Meeting Minutes Planning Commission

- c. 160 Lorton Avenue (Parking Lot N), zoned R-4 - Update of a previously approved five-level parking garage. (Chris Grant, The Pacific Companies, applicant; City of Burlingame, property owner; Watry Design, Inc., designer) (298 noticed) Staff Contact: Ruben Hurin

RE: Burlingame Village and Lot N Parking Structure
WDI Job #17030.112

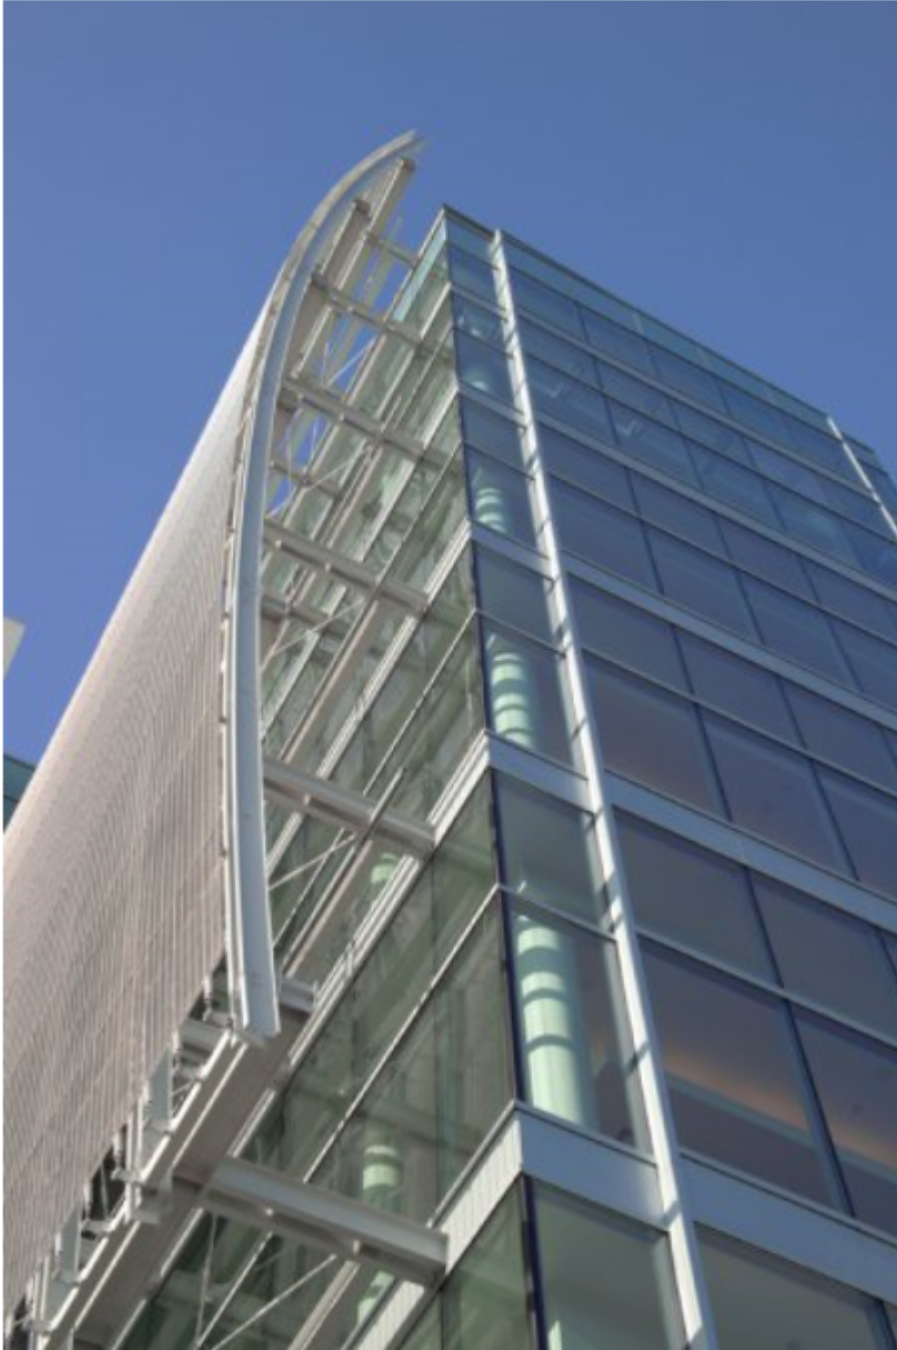
- > *Scale of screen is beautiful and elegant, however the 6x8 horizontal members are large and chunky, so there is a big scale difference between these components. Don't know what mediates between those two elements. Did see that there are details that show an L-bracket and a capture, so that it appears that the screen is hanging from the L-bracket at the top, but don't know what happens in between, unless it's captured in an edge capture strung between two L-brackets, and how it's kept tight.*

- > *Would be helpful to see connection and finish details on the edges and how panels would join together.*
- > *Would be helpful to see photographs of this installation on other buildings.*

Pursuant to our meeting with maintenance, in order to address their concerns with the architectural mesh at the “curved” stair, we propose to change the stair to a rectangular shape similar to the stair on Lorton as shown on the attached drawings. This will allow us to avoid having to stop the mesh at the stair landing which was not looking clean and making the installation much more complicated. This design will also avoid the concern that they had regarding the butted joints at the separate mesh panels.

1. The large curved section above the vehicle entries, can be fabricated from 3 panels of equal width approximately 12’ wide by 36’ high each. The panels will butt to each other but will not be connected for structural reasons. The edges of each panel will be burred to keep them straight and neat. The panels will be supported by curved steel tubes and tensioned at the bottom with matching straps. We understand that the Planning Commission was concerned with the dimensions of the steel tubes. However, these are sized to withstand the structural loads and minimize the total number of supports required.
2. The mesh at the stairs will be made up of a single panel of approximately 14’ width and 51’ height. The edges will be treated similarly. The panels will be supported from a steel angle at the concrete roof and tensioned at the bottom with matching straps.
